PLANNING COMMISSION MEETING

A. Public Hearing: Review of Development Application for 'Wilds on Wayzata' Proposed Subdivision, 925 Wayzata Boulevard W (Flip & Gina Carlson, Wilds on Wayzata LLC / Property Owners: Dylan Carlson & Alec Martinez)

Planning Commission Agenda Report

A RESOLUTION DENYING REQUESTS FOR A PLANNED UNIT DEVELOPMENT MASTER DEVELOPMENT PLAN, REZONING TO THE PLANNED UNIT DEVELOPMENT DISTRICT, AND PRELIMINARY AND FINAL PLAT FOR WILDS ON WAYZATA

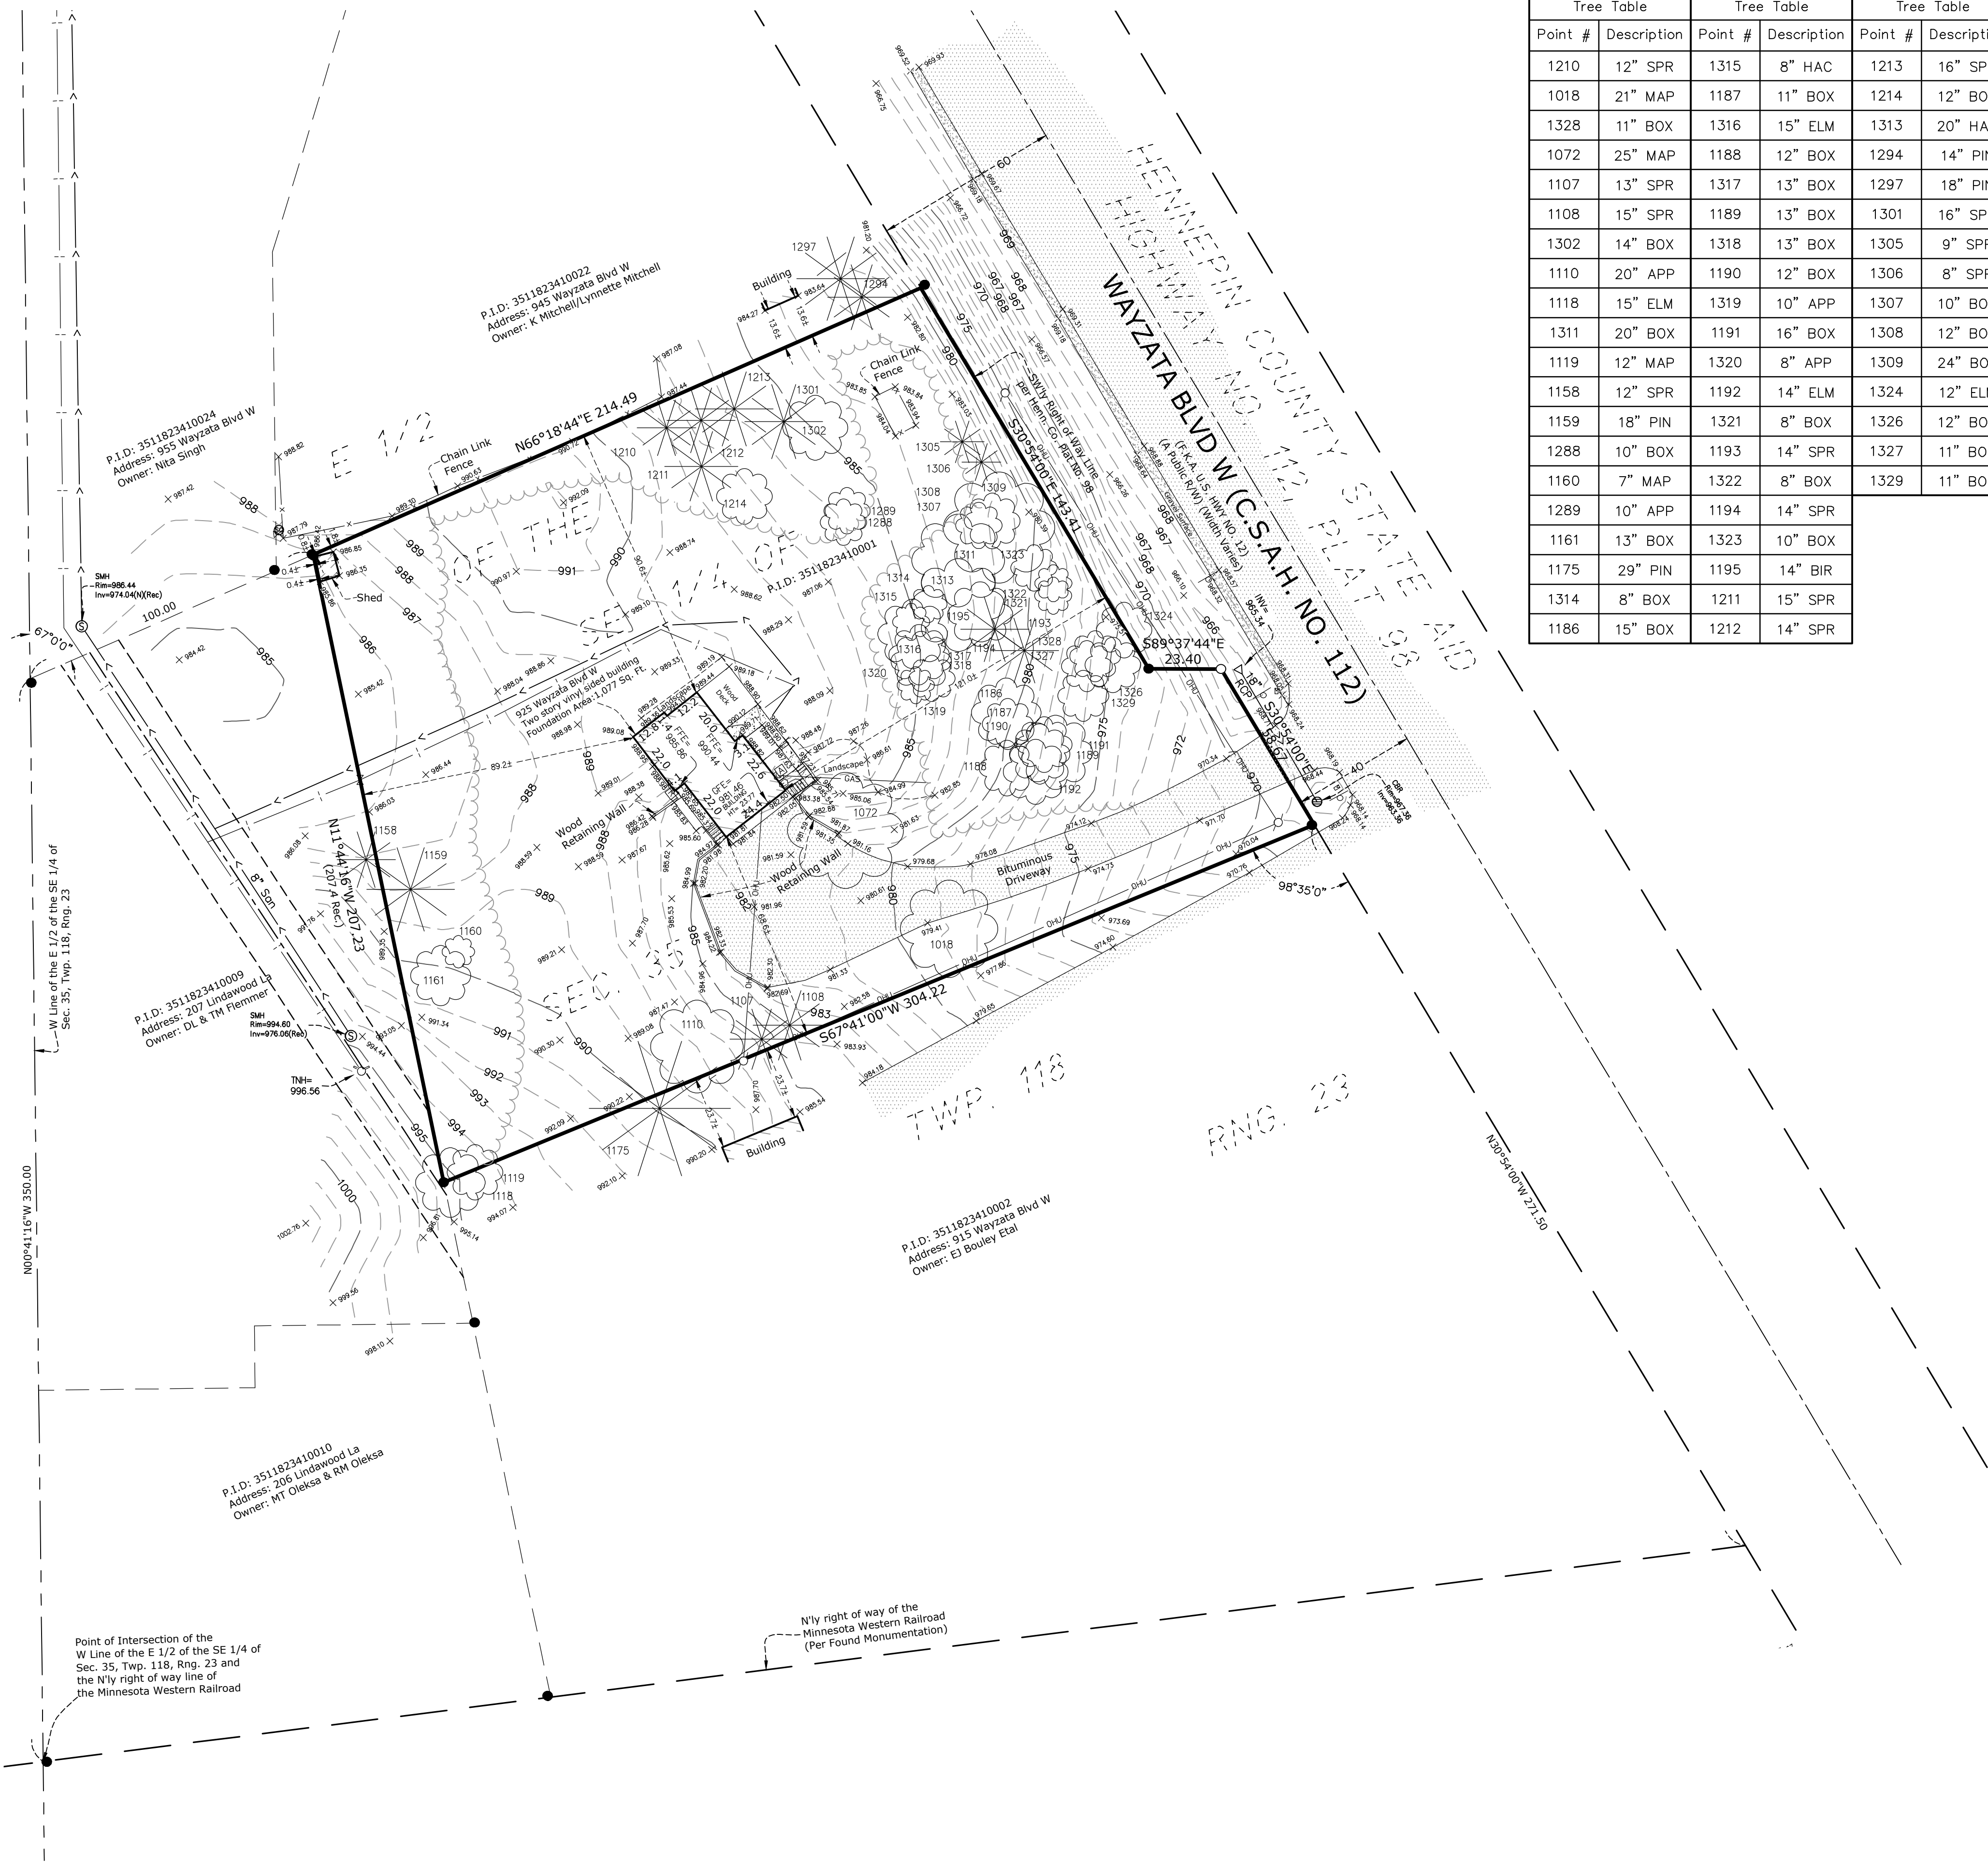
- The existing topography on the ALTA survey is insufficient to understand drainage patterns between the subject property and adjacent properties. Topography must be shown a minimum of fifty feet beyond the boundary of the subject property on this, and all other plan sheets with topography shown.
- This plan sheet identifies an existing catch basin in the right-of-way for Wayzata Boulevard near the southeast corner of the site. There is no outlet pipe for this catch basin shown. This information must be included on this plan sheet and all other applicable plan sheets.

GRADING PLAN

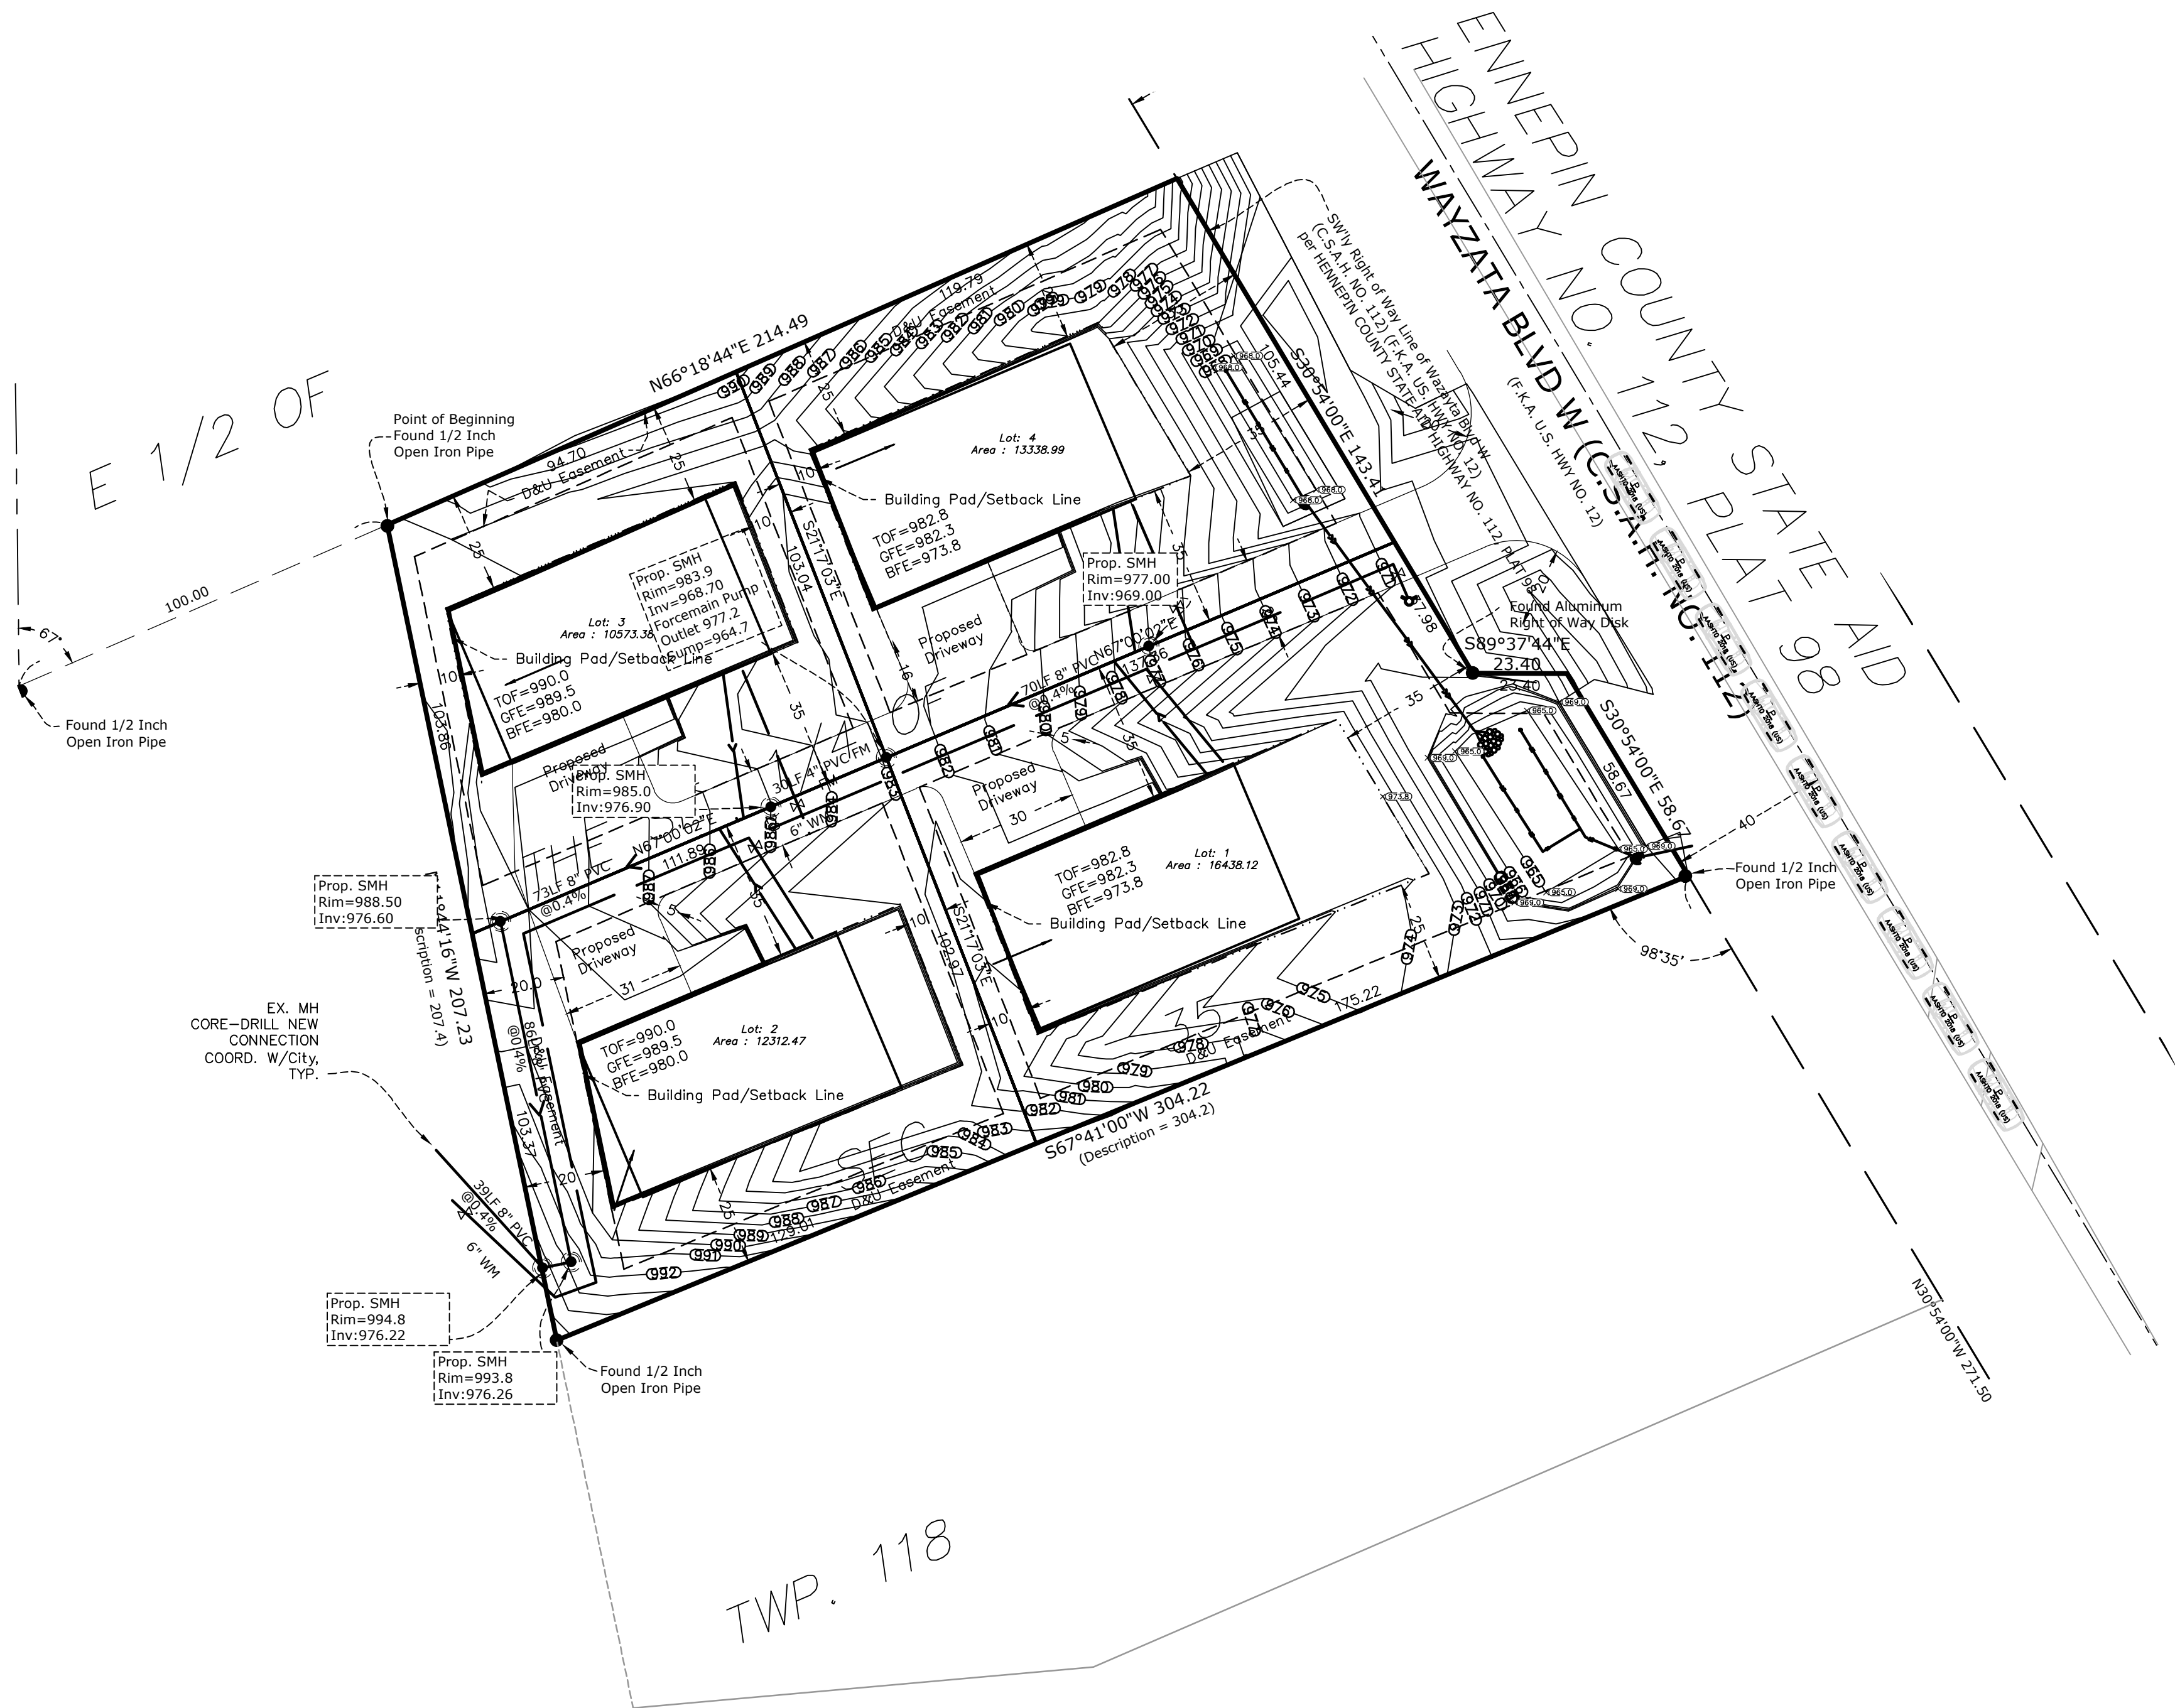
The Applicants have not submitted a Tree Preservation or Landscape Plan. Based upon the Grading Plan provided, most if not all of the trees would need to be removed to accommodate this development. Additionally, it appears that the root systems of trees located on neighboring properties will be impacted by the proposed grading. This proposal is in conflict with the following provisions located in *Section 33: Tree Preservation and Landscape Standards*:

- c. Submission of a Tree Preservation Plan depicting all mature trees that will be saved or removed (on both the subject property and trees located on neighboring properties that could be impacted)
